### Remarks

Applicant's invention is directed to a multipackage module having an inverted second package stacked over a first package, in which the z-interconnection between the stacked packages is by wire bonds, and in which at least one of the packages is provided with an electrical shield. The multipackage module according to Applicant's invention is made by providing a first package having an electrical shield, stacking a second package in an inverted orientation onto an upper surface of the shield, and electrically interconnecting the packages by wire bonds. According to the invention, the packages may be individually tested, and only packages determined to be "good" are used to assemble the stacks, providing improved yield in the resulting multipackage modules.

The attached sheets of drawings include changes to FIGs. 6B, 7A, 7B, 7C and 8B. Sheet 5 / 20, which includes FIGs. 6A and 6B, replaces original sheet 5 / 20 including FIGs. 6A and 6B; sheet 6 / 20, which includes FIGs. 7A and 7B, replaces original sheet 6 / 20, including FIGs. 7A and 7B; sheet 7 / 20, which includes FIG. 7C, replaces original sheet 7 / 20, including FIG. 7C; sheet 8 / 20, which includes FIGs. 8A, 8B

Fig. 6B

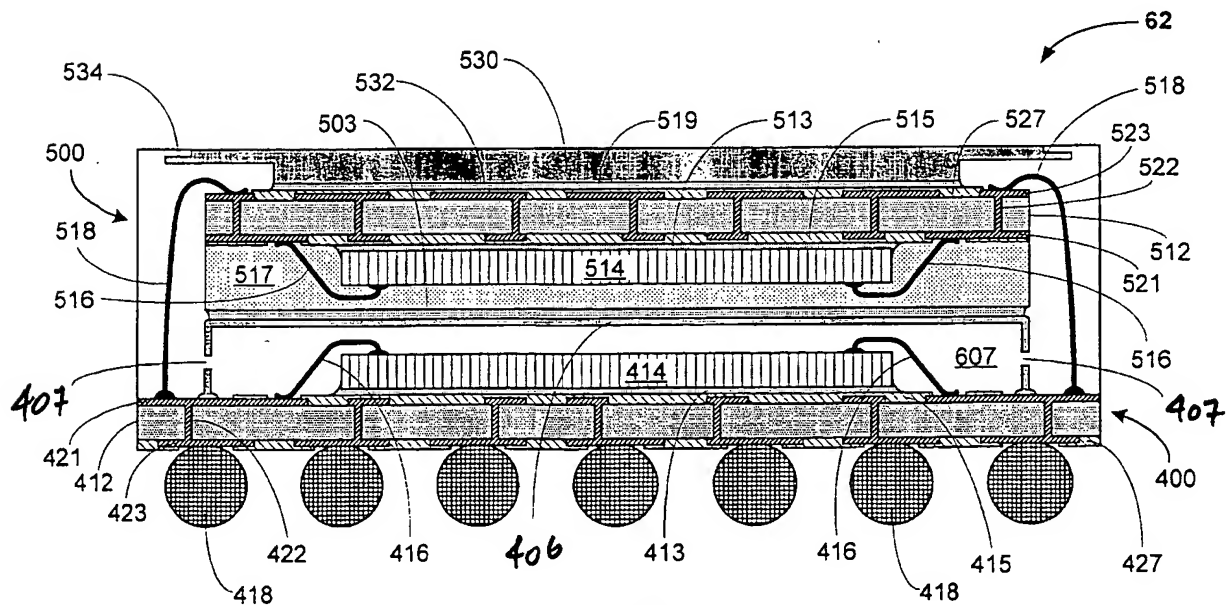
FIG. 6B is amended herein by insertion of missing reference numeral 406, and 407 (2 instances), to be consistent with the description and with the reference numeration of FIG. 6A.

Fig. 7C

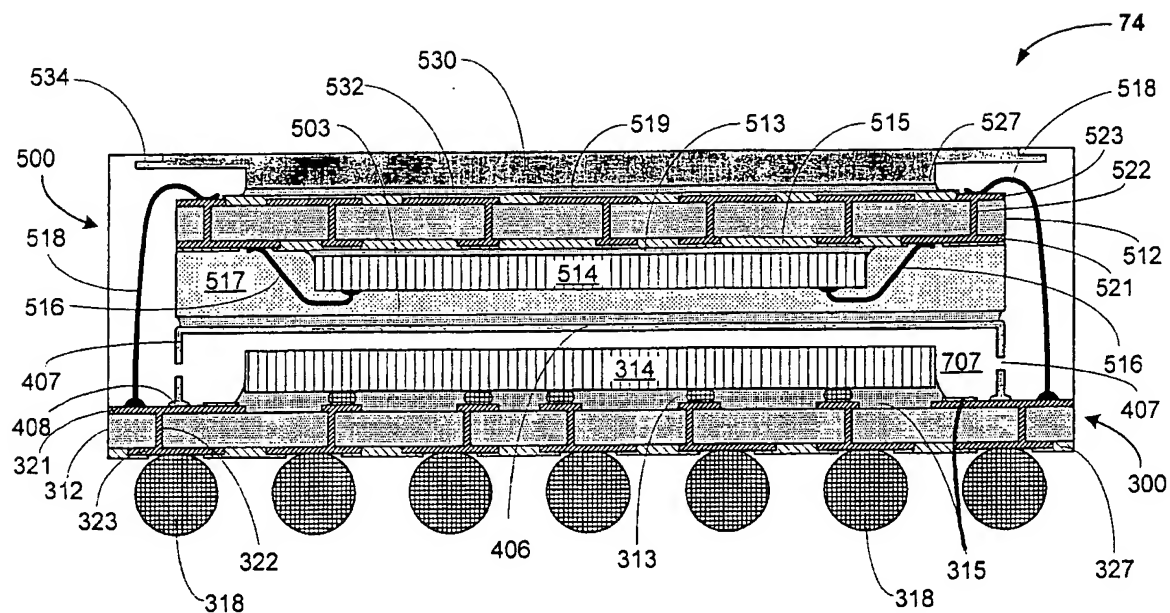
The Examiner objected to the drawings as failing to comply with 37 CFR 1.84(p)(4), asserting that "reference characters '313' and '315' have both been used to designate the adhesive" and noting that it was unclear where the lead line from reference numeral "315" pointed. Accordingly, in FIGs. 7A, 7B and 7C, the lead line from reference numeral **315** is moved, to indicate the "solder mask", see paragraph [00140]. It is noted that reference numeral **313** indicates the underfill, see paragraph [00136].

Fig. 8C

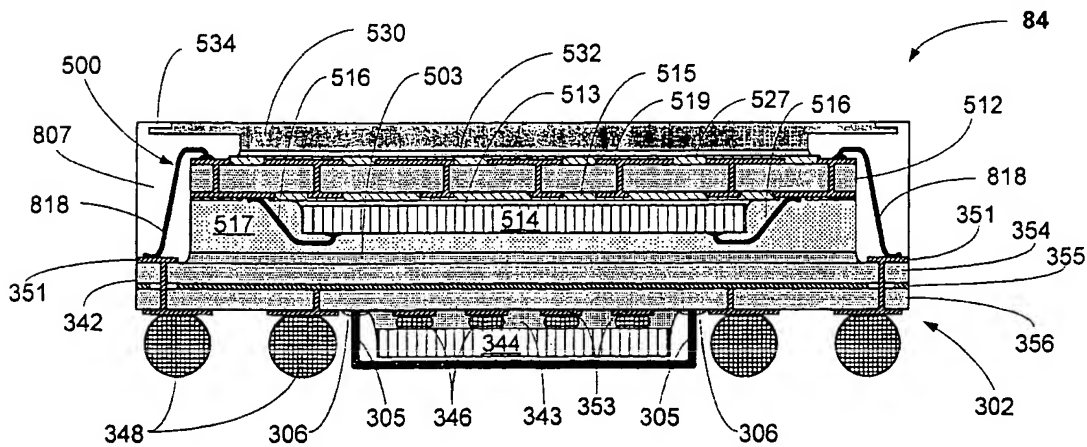
"355" is replaced with -- 305 --, "356" is replaced with -- 306 --, and "354" is replaced with -- 304 -- (paragraph [00165]) to make the text consistent with the reference numeration of FIG. 8C and to avoid use of any reference numeral to identify more than one feature. It is noted that metal layer 355 is sandwiched between dielectric layers 354, 356 in bottom package substrate 342 (*see, e.g.*, paragraph [00157], FIGs. 8A, 8B, 8C). Accordingly, FIG. 8B is amended to make the reference numeration consistent with that of FIG. 8C, by replacing the instances of reference numerals 354, 355, 356 that are directed to the lower planar part and the legs or sidewalls of the heat spreader, and the adhesive by which the heat spreader is affixed to the substrate, with, respectively, numerals 304, 305, 306;
